***Review of the Technology
Costs and Effectiveness
Utilized in the Proposed SAFE
Rule***

Final Report

California Dept. of Justice
Sacramento, CA

H-D Systems
Washington, DC

Figure 3-1: Technology Pathways used in the PRIA

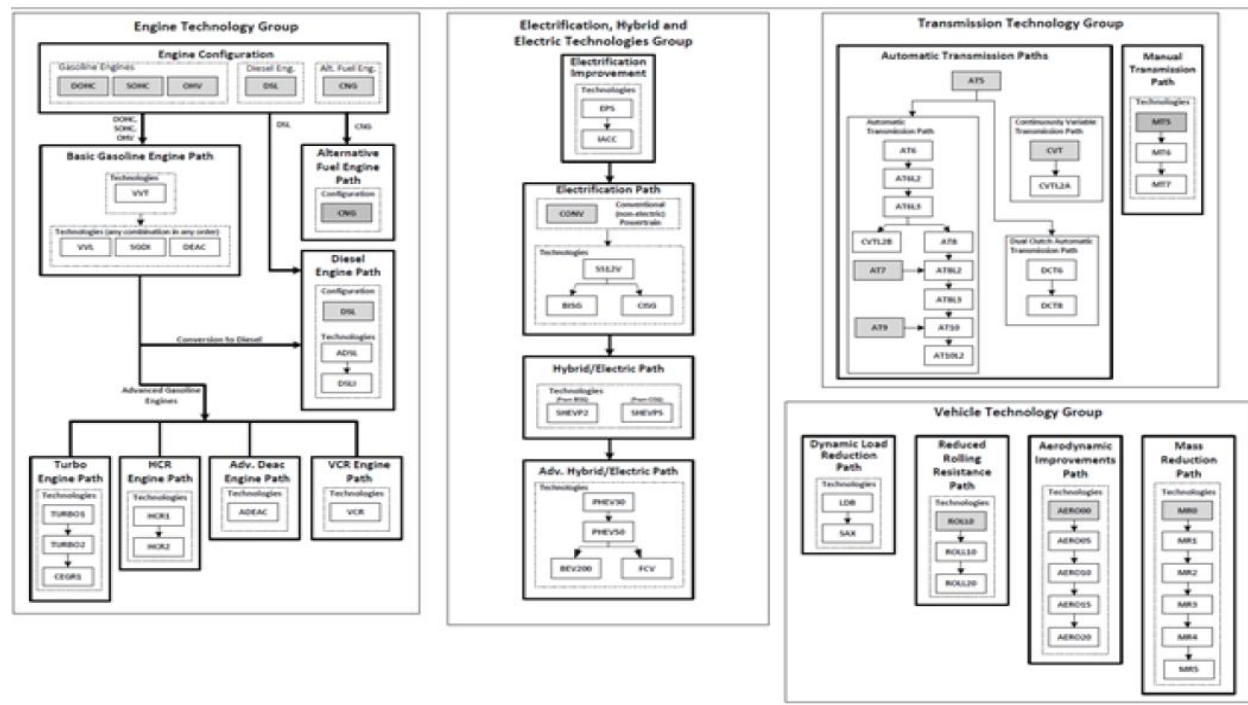
Based on the pathways, we assumed that the baseline did NOT contain any friction reduction technology, and the base path (first box under configurations on the left of Figure 3-1) included lubricant technology, while all of the advanced engines included lubricants and both levels of friction reduction modeled in the 2016 TAR as this gave the closest match to aerodynamic results

In general, the PRIA and TAR numbers agree within relative 5% (e.g., 10% vs 10.5%) if our technology application is correct except in the case of Turbo + cooled EGR. It should be noted that the PRIA analysis estimates zero benefit for cooled EGR relative to Turbo – 24 bar technology. The PRIA has modeled the HCR2 engine but has not included it in its analysis of compliance pathways. The PRIA states that the engine map “was developed assuming high octane Tier 3 fuel and had unresolved issues associated with knock mitigation and cylinder deactivation” used in the 2016 analysis. On the other hand, the 2018 analysis included Advanced Cylinder De-activation (ADEAC) which has recently come to market readiness.

Figure 4-1: Key Technologies on Toyota's ATK2 Engine

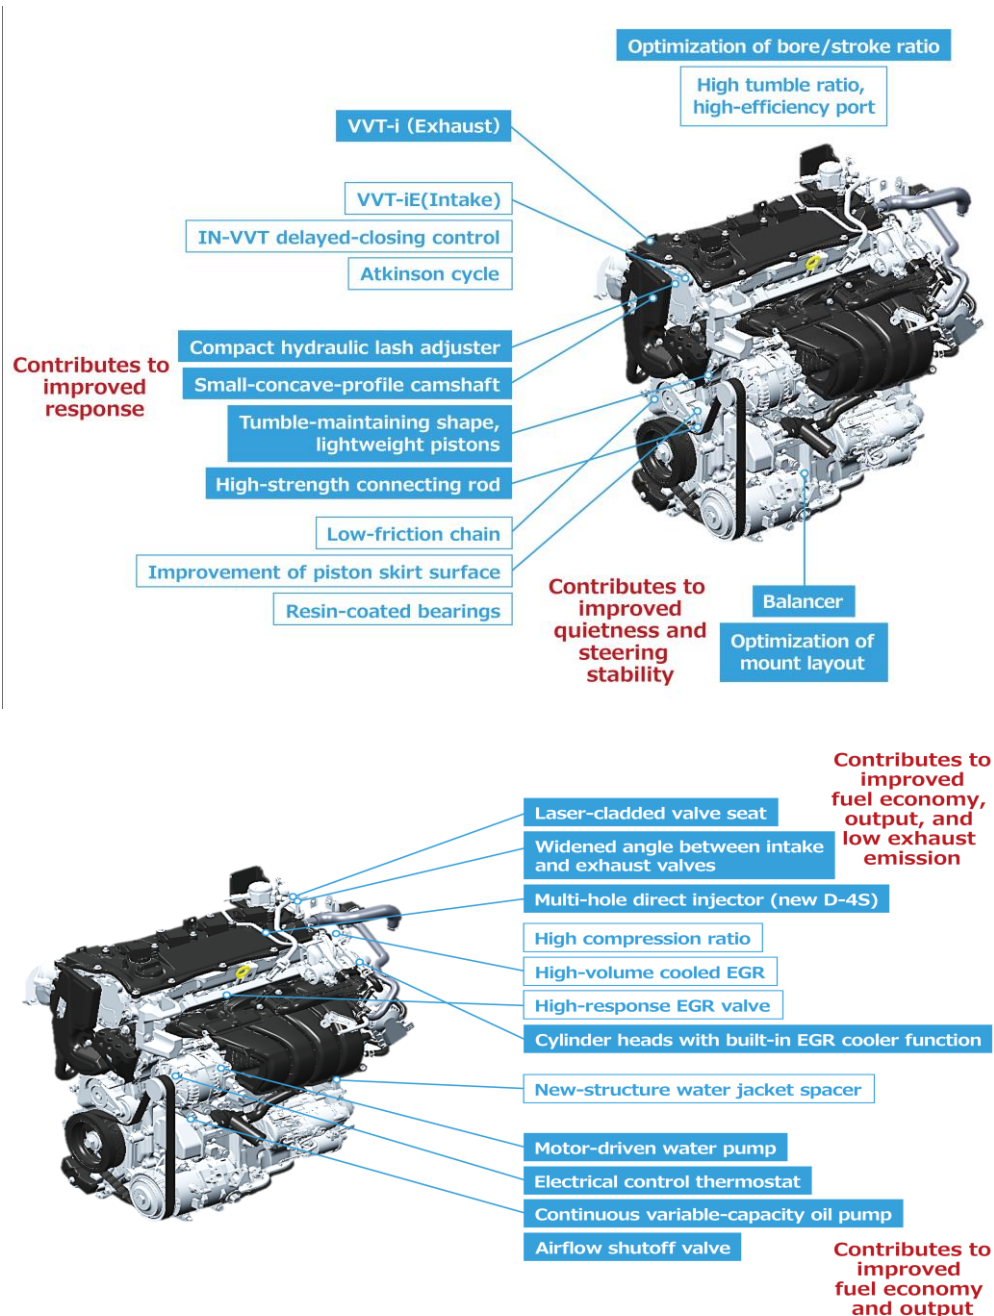
The cost data developed for the ATK2 engine by EPA was based on an extensive effort using the Mazda ATK1 engine modified by EPA, and started with benchmarking of a production, unmodified MY2014 U.S.-market Mazda SKYACTIV-G 2.0L 4-cylinder Atkinson Cycle engine with a 13:1 geometric compression ratio. EPA subsequently developed hardware to permit the ATK1 engine to operate at ATK2 level of compression ratio with cooled EGR. The hardware development, engine dynamometer testing, model validation and updating of the GT-POWER model represent significant further study and development of these technologies. In the Draft 2016 TAR states that EPA “has completed much of this work, which as explained earlier, confirms that our estimates for the Proposed Determination are appropriate”, showing a higher level of confidence in the \$110 cost estimate.

The PRIA estimate of \$317 is undocumented but sources at ARB have suggested NHTSA based this cost on the bulky exhaust system used in the Mazda ATK1 engine, which apart from being expensive also requires the vehicle to be modified to accommodate the exhaust system. In 2018, Toyota introduced the ATK2 engine into the US market in the Camry. The 2018 Camry is the most efficient non-hybrid midsize car sold in the US, and is rated at 46.84 mpg, which is 27% higher than the 2016 model shown in Table 4-1 obtained from a Toyota press release. The 2018 Camry does not have the bulky exhaust of the Mazda and press releases on the engine by Toyota show the changes made as described in Figure 4-1. None of the engine changes, with the exception of the direct injection system and cooled EGR, are expensive, and these two components have been costed in detail by

EPA. Other technologies such as the motor driven water pump and variable oil pump contribute to Camry's high efficiency but are not specifically required for the ATK2 engine. However, ATK2 technology has no effect on the PRIA cost estimates as it was not used for the forecast.

Figure 4-2: Delphi Estimates of 48V Systems Cost

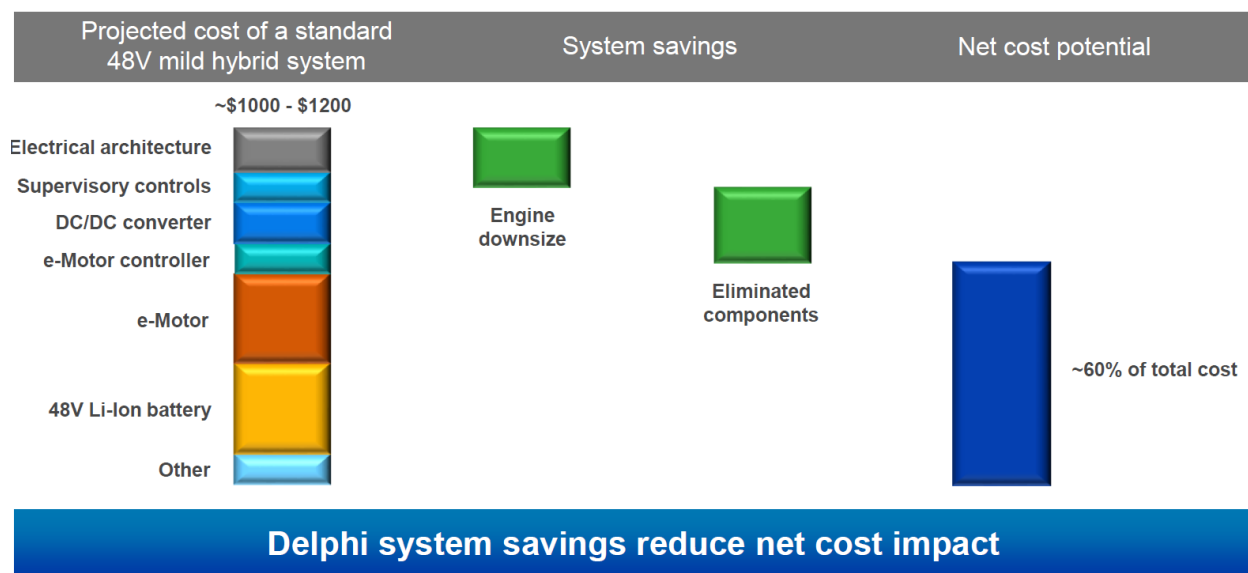
The costs of the modern 48V system has been publicly discussed by Delphi⁵, a supplier of such systems, and their estimates of the total cost before savings is in the \$1000 to \$1200 range (depending on vehicle size) as shown in Figure 4-2 above. However, the system affords the elimination of the 12V starter, alternator and battery and reduced costs for the electric power steering for a saving of about \$200, and Delphi also claims some savings from engine downsizing potential. Even if the engine cost reduction is ignored, the net cost will be \$800 to \$1000, which is much closer to the TAR estimate than to the PRIA estimate. The 2016 battery cost estimate is potentially too high with recent rapid decreases in lithium-ion battery costs, as discussed in more detail below. A separate factor driving vehicles towards 48V solutions is autonomous driving technology which requires 1.5 to 2 kW of power in the vehicle. It is difficult

Figure 4-3: Incremental Retail Price of Hybrids in MY 2014

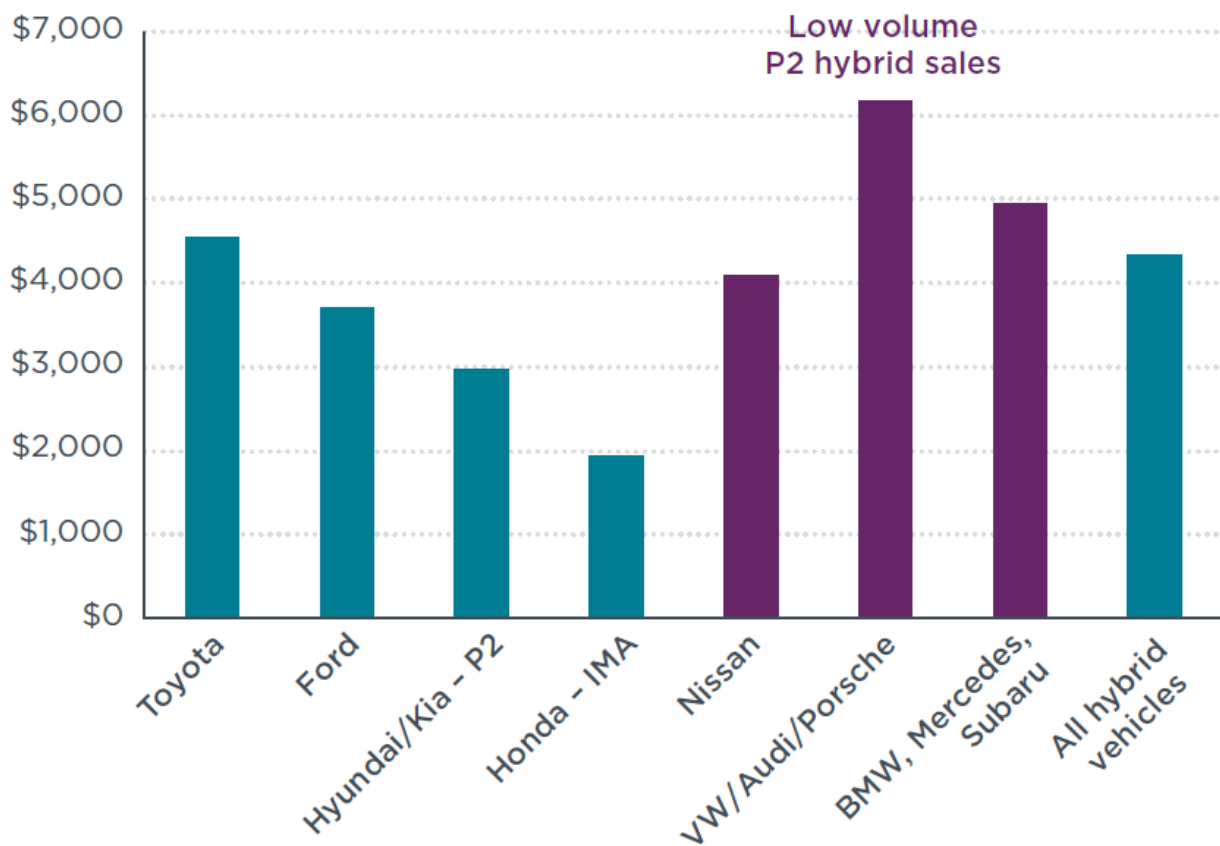
The typical cost-to-retail price ratio is 1.5, so that the cost of the PS hybrid which is used by Ford and Toyota is in the \$2500 to \$3000 range, in good agreement with the teardown-based

estimate. The cost of the P2 hybrid from Hyundai Kia would be \$2250 which is lower than the TAR estimates, but Honda's IMA system is more akin to a mild hybrid system. Costs even for low volume and/or luxury models are not substantially higher, with the BMW/Mercedes/Subaru estimate equivalent to a \$3300 cost for the P2 hybrid.

Figure 4-4: Incremental Costs of Mass Reduction from Honda Accord Study in 2016 TAR

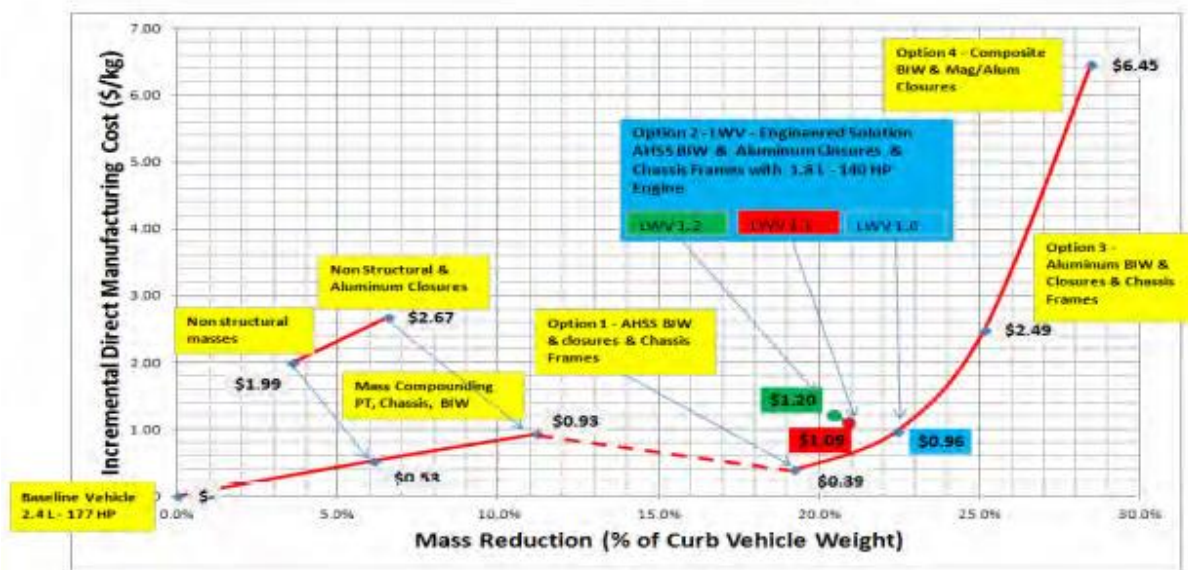
The base Honda Accord weighed 1480 kg and each 1% represents a 14.8 kg reduction in weight. The incremental cost for the first 6.1 % weight reduction is \$0.53/kg which translates to total cost of about \$48 for a 90 kg weight reduction, while the next 5% costs \$0.93/ kg, or a total cost of \$71 for a 73 kg. weight reduction. Hence the 11.1% reduction in weight (163 kg) costs \$119 for an average cost of \$0.73/kg. However, the PRIA estimates that a 175 kg weight reduction has a cost of \$536 (table 6-38 in the PRIA) but no explanation is provided for the very large cost difference.

Figure 4-5: TULA Estimates of the Costs and Effectiveness of ADEAC and 48V Hybrid Technology

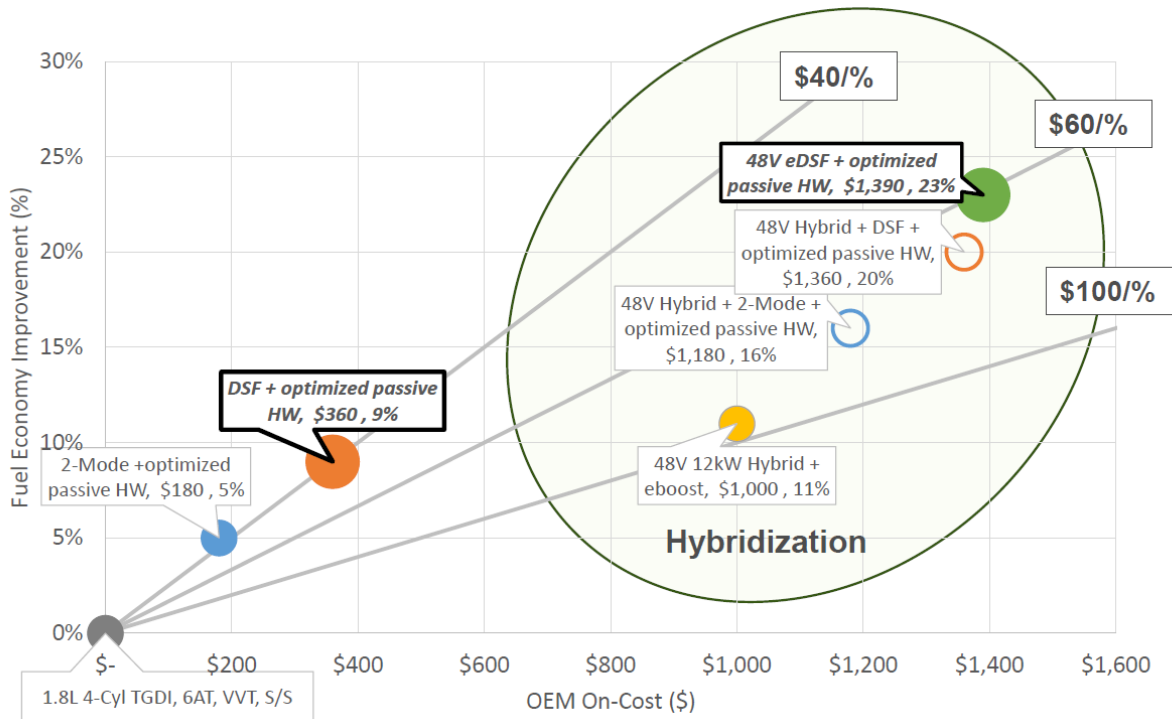
In a presentation on the effectiveness of the ADEAC system and the combined effectiveness of ADEAC and a 48V mild hybrid system, TULA Technologies¹¹ provided information on the cost and benefit of ADEAC and mild hybrid systems effectiveness and costs both singly and in combination, and Figure 4-5 shows the benefit of the 48V mild hybrid system as 11% fuel economy (10% fuel consumption) and the combined benefit of ADEAC +Mild Hybrid as 23% fuel economy (18.7% fuel consumption). It is not clear why the Autonomie modeling used in the PRIA produces such a low estimate of the effectiveness of mild hybrid systems. Even if the TULA presentation is regarded as optimistic about the effectiveness since they are developers of the technology, the EPA modeling results of 8 to 9% effectiveness appear reasonable in the light of what is observed from certification data.

Figure 4-4: Distribution of Tire RRC in the 2016 fleet Shown in PRIA

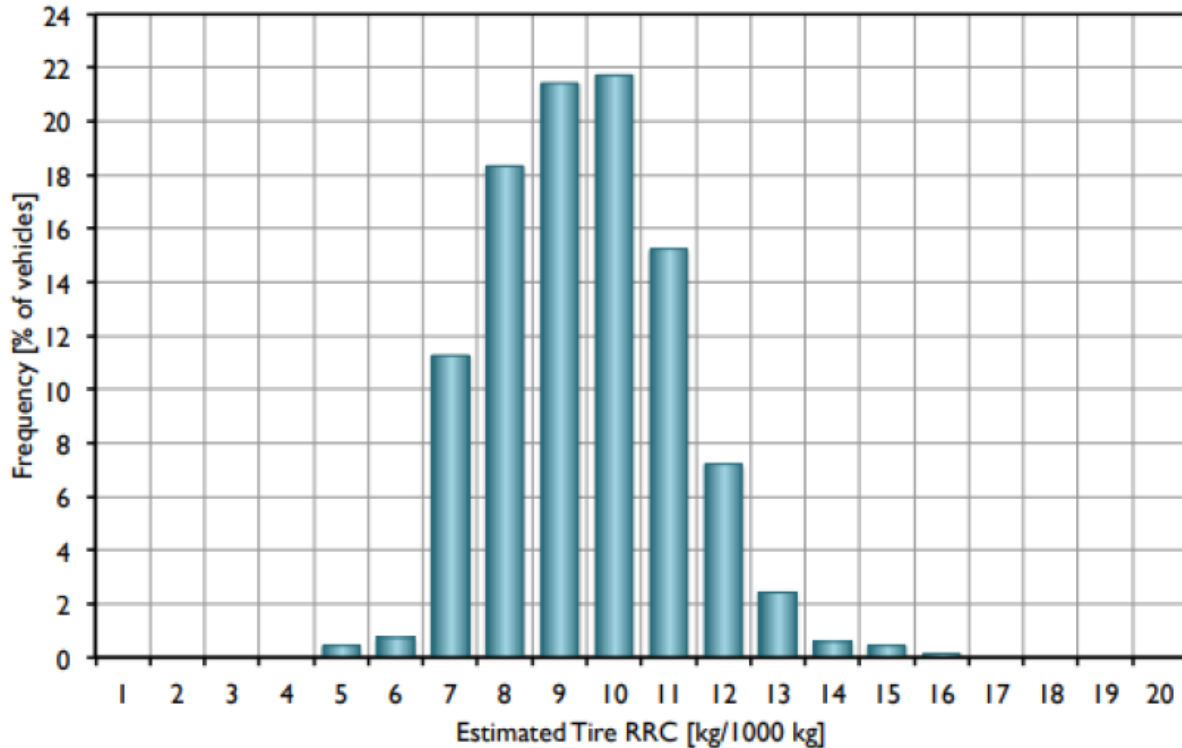
Figure 4-4 shows there is a very significant fraction of the fleet with tire RRC above 10 kg/1000 kg, or 0.10 and a small percentage of vehicles with RRC already at 0.05 or 0.06. In their analysis, NHTSA assumed the baseline of 0.09 (which appears a little low but may be appropriate if the distribution was sales weighted) and had only two levels of rolling resistance reduction from the baseline – by 10% to 0.081 and 20% to 0.072. There are a significant number of vehicle models currently offered with tires at levels below 0.07 and it is unlikely that there will be no tire improvements over the next decade, and even current data shows that a ROLL30 technology, or 30% reduction to an RRC of 0.063, is possible and appropriate for MY2025. In addition, the baseline accounts for the distribution of tires blow 0.09 as 19% of vehicles in MY 2016 are modeled as having used ROLL10 and 25% of vehicles as having used ROLL20 in the base year, but there is no accounting for the ~25% of vehicles having RRC values 10 to 20% above the 0.09 RRC average. A stricter accounting of the baseline and, possibly setting specific lower limits for 2025 RRC by vehicle type (as done for aero drag in the PRIA) will show significant additional fleetwide effectiveness from RRC reduction which is a very cost-effective technology.
